Lincoln Heights Preliminary Overall Area Development Plan

MASTER DEVELOPMENT PLAN / MIXED USE DEVELOPMENT

THE VILLAGE AT QUARRY MARKET

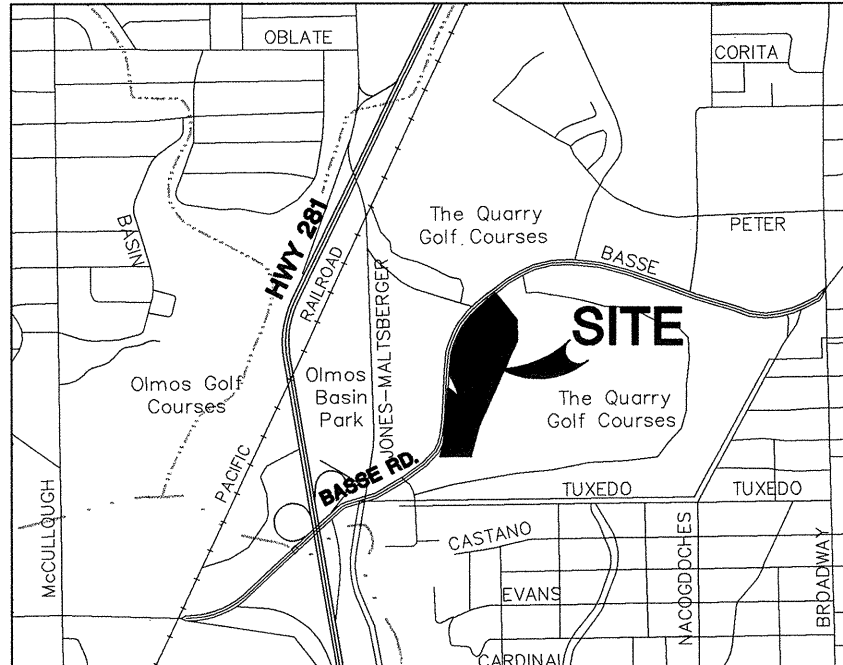
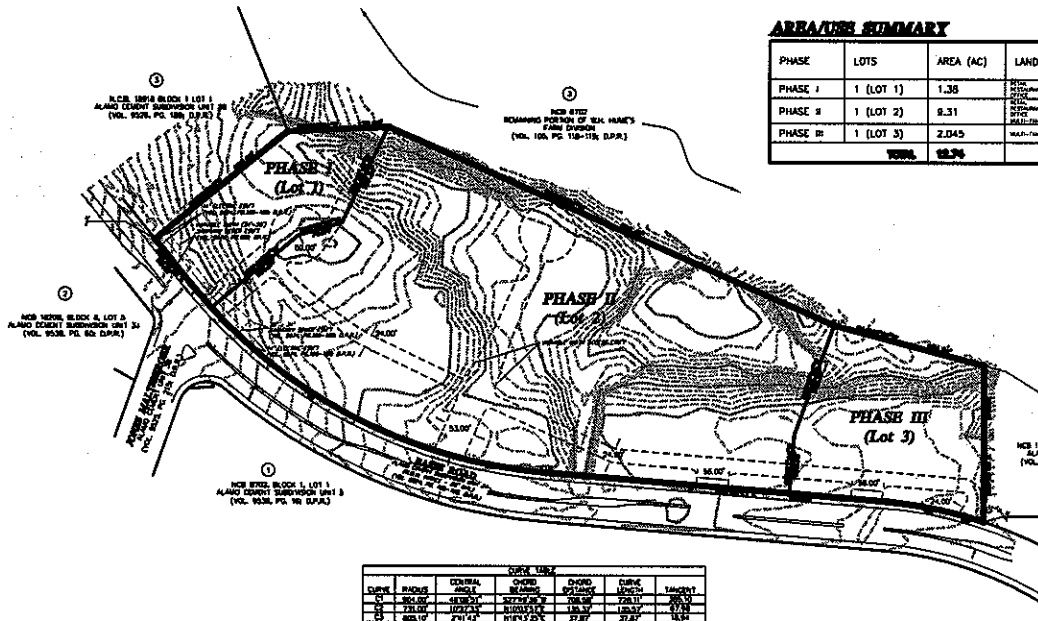
Comments: 1. PROVIDE COORDINATES ON 27 CORNERS OF THE PROJECT
2. PROVIDE A SITE PLAN
3. LABEL GOLF COURSE
4. SHOW DRIVEWAYS ^{ON} OPPOSITE SIDE OF THE PROJECT.
5. ADD MIXED USED DISTRICT (MXD) TO TITLE

Master Development Plan: 1/6/2005
1. Provide 2 point coordinates
2. Provide a master site plan
3. Label Golf Course
4. Show the driveways on the opposite of Basse Rd.
5. Add Mix Used District (MIX) to the Title
MASTER DEVELOPMENT PLAN / MIXED USED DISTRICT

- 1. that the following "General Note" be added:**
-This MDP is subject to the site plan approved as part of Ordinance # 99626

-Change General Note number 4 to further indicate that the setbacks will conform to the TND regulations in Section 35-207 of the Unified Development Code, and

1. A letter/agreement is required from the owner of the Quarry Golf Course prior to approval of the MDP. The plan shows to concentrate the increase in runoff to an area (private property) that is not currently dedicated as a drainage easement. The owners of the Golf Course must understand the effects of the increase in runoff through their property to the existing pond and agree to accept the increase. Please provide a copy of the agreement to our office.

While the engineer has included a note on the plat indicating that the MDP is subject to UDC 35-503, the plan does not indicate how the development will comply with the requirements. If onsite parkland is to be dedicated, then a site plan must be submitted for review.

35-503(d)(2) requires the submittal of a Parks and Open Space Provision and Maintenance Plan. This was not submitted with the plan package.

The MDP has been revised per the conditions you requested. Please see below.

"All development on the subject property will generally comply with the site plan approved by City Council as part of the rezoning to MXD (Ordinance # 99626). Minor revisions, as outlined in Section 35-412(g) of the Unified Development Code, may be made to the site plan."

If the following change is made to the MDP, Zoning will approve it:
Add a note that indicates that "All development on the subject property will comply with the site plan approved by City Council as part of the rezoning to MXD (Ordinance # 99626)."
